SERVICE BULLETIN

M-1179

Safety Recall Code 0121

SAFETY RECALL-2006 FLHXI MIRROR RELOCATION

Figure 1. Drilling Template Position

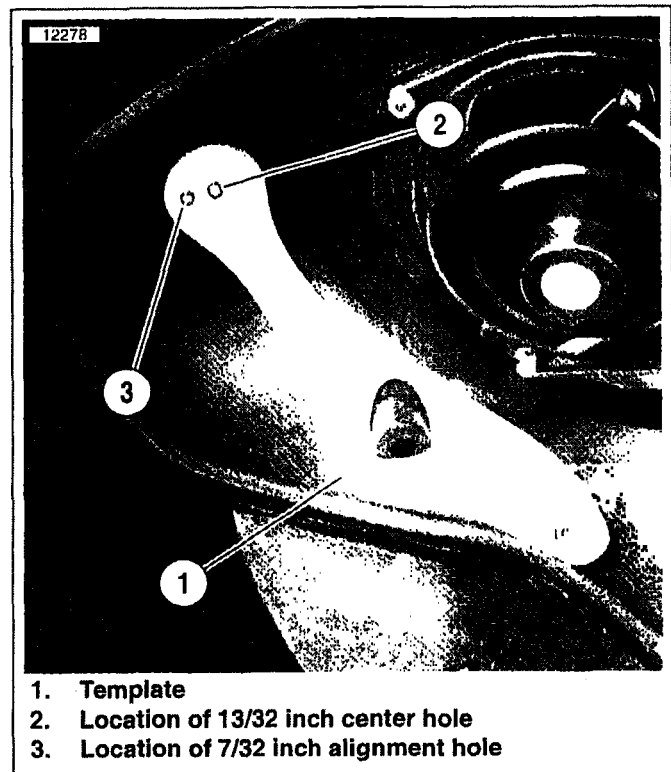
1. Obtain a drilling template. One template is included in each decal kit and in each mirror kit.
2. See Figure 1. Place template (1) on inside of inner fairing as shown to locate mounting holes for mirror. Make sure entire template lays flush against fairing contour.

3. Begin by drilling a 1/8 inch (3.175 mm) pilot hole at each location (2, 3) marked on the template. Remove template.
4. For the center hole (2) where the 3/8 inch (9.525 mm) threaded stud passes through the fairing use a 13/32 inch (10.319 mm) diameter twist drill to drill the hole to its final size. For the alignment hole (3), use a 7/32 inch (5.556 mm) diameter twist drill to drill the hole to the final size.

Figure 2. Decal

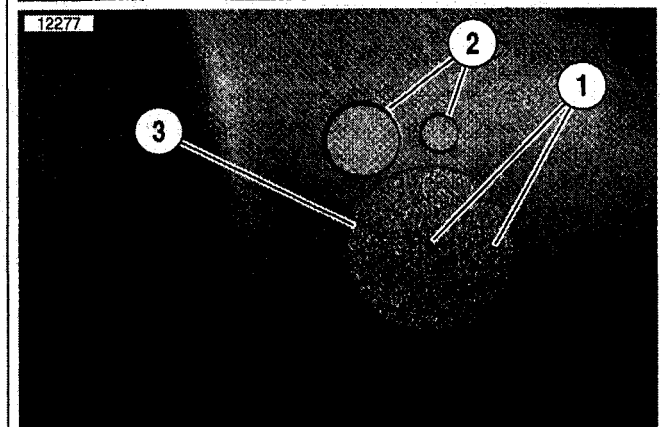
5. Deburr holes and clean drilling debris from fairing.
6. See Figure 2. Peel backing from decal. Carefully position decal over old mirror mounting holes on outside of inner fairing; place decal as close to new holes as possible, making sure that decal completely overlaps and covers old holes. Press decal in place.

Figure 3. Option 1 Complete

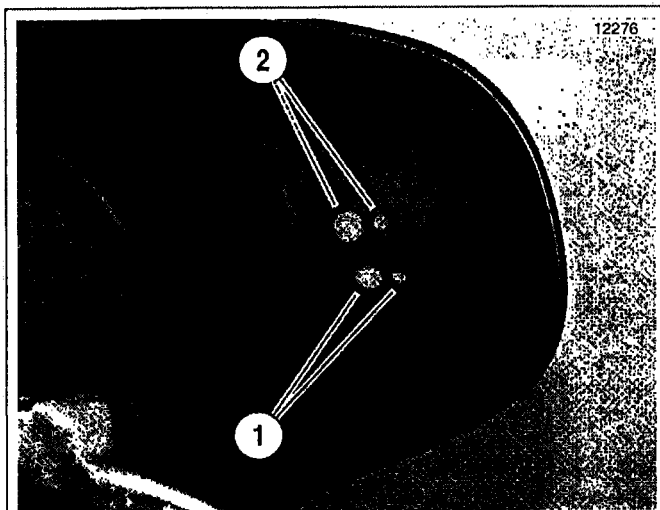
7. Repeat steps 2 – 6 at other mirror location.
8. Install mirrors in freshly drilled locations. See MIRRORS in the TOURING MODELS SERVICE MANUAL. See Figure 3. Do NOT tighten flange nut to more than 15 In-lbs (1.7 Nm).
